MIL-L-63460D
INT AMENDMENT 4(AR)
27 MAY 1993
USE IN LIEU OF
AMENDMENT 3
1 JULY 1987

MILITARY SPECIFICATION
LUBRICANT, CLEANER AND PRESERVATIVE FOR WEAPONS AND WEAPONS SYSTEMS

This interim amendment is approved for use within US Army Armament Research, Development and Engineering Center, with MIL-L-63460D, dated 5 August 1985.

FIGURE 2. Bottle, 0.5 Oz Cylindrical.

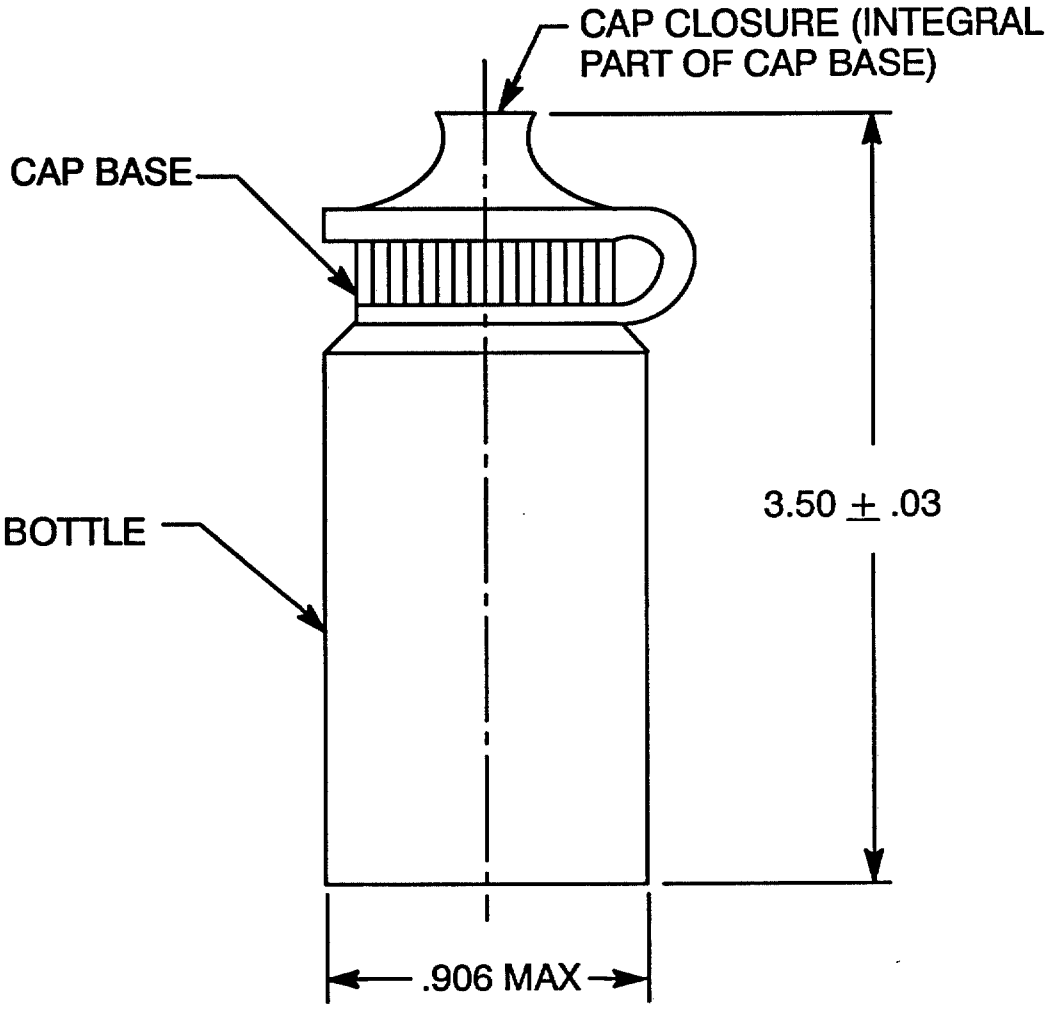
5.1.2 Bottle, 0.5 oz. When the unit container specified is of the 0.5 oz size, the bottle material and dimensions shall conform to Figure 2.

6.6: DELETE reference to "9150-01-079-6123" and "1.1 fl oz plastic bottle IAW drawing", and INSERT in place "9150-01-102-1473" and "0.5 oz plastic bottle (See Figure 2)".
